Origination Form

Proposed Revisions to a Standard Plans Index

Originator:	Turley, Joshua	Index Number:	455-118
Date:	8/21/2024	Sheet Number(s):	2
E-mail:	Joshua.Turley@dot.state.fl.us	Index Title:	18" SQUARE CFRP & SS PRESTRESSED CONCRETE PILE

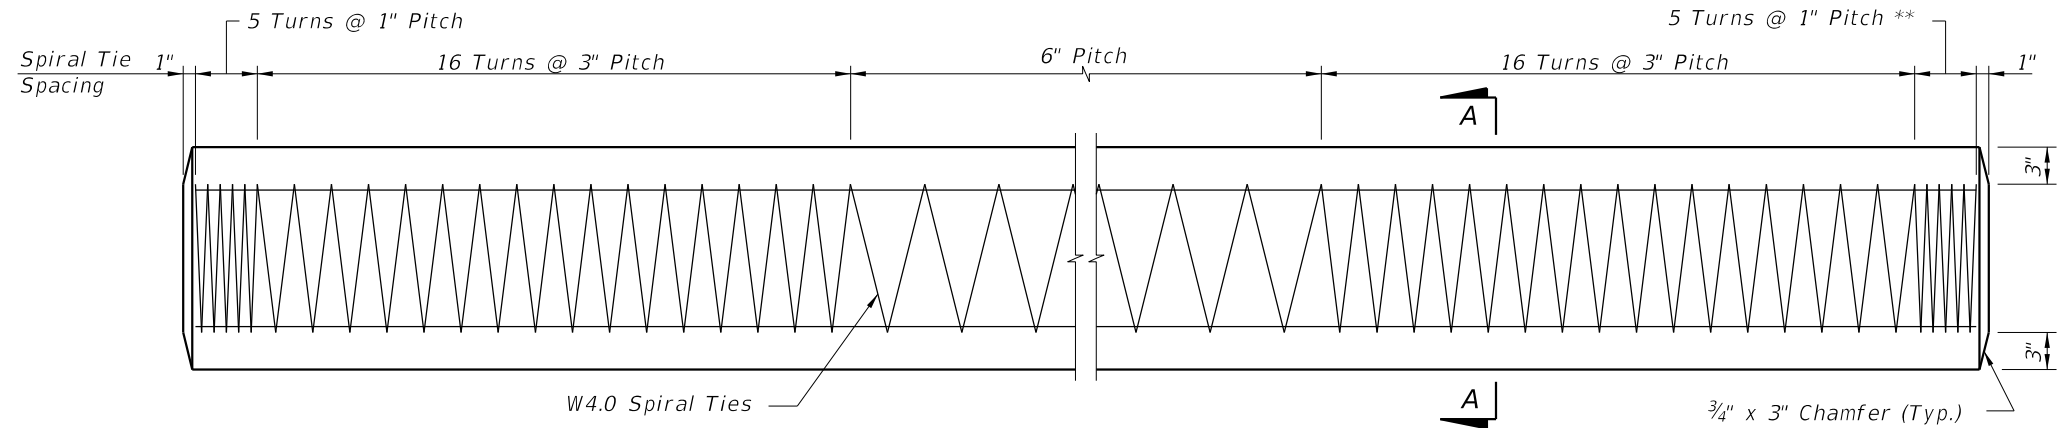
Sheet 2: Adjusted Strand Pattern diameter decimal places

STRAND PATTERN

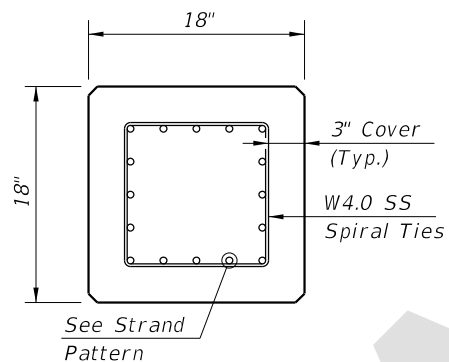
This is a more accurate representation of the nominal diameter driven by the fact that the strands are fabricated in millimeters not inches.

16 ~ 0.52" Ø, HSSS, at 26 kips
12 ~ 0.62" Ø, HSSS, at 35 kips
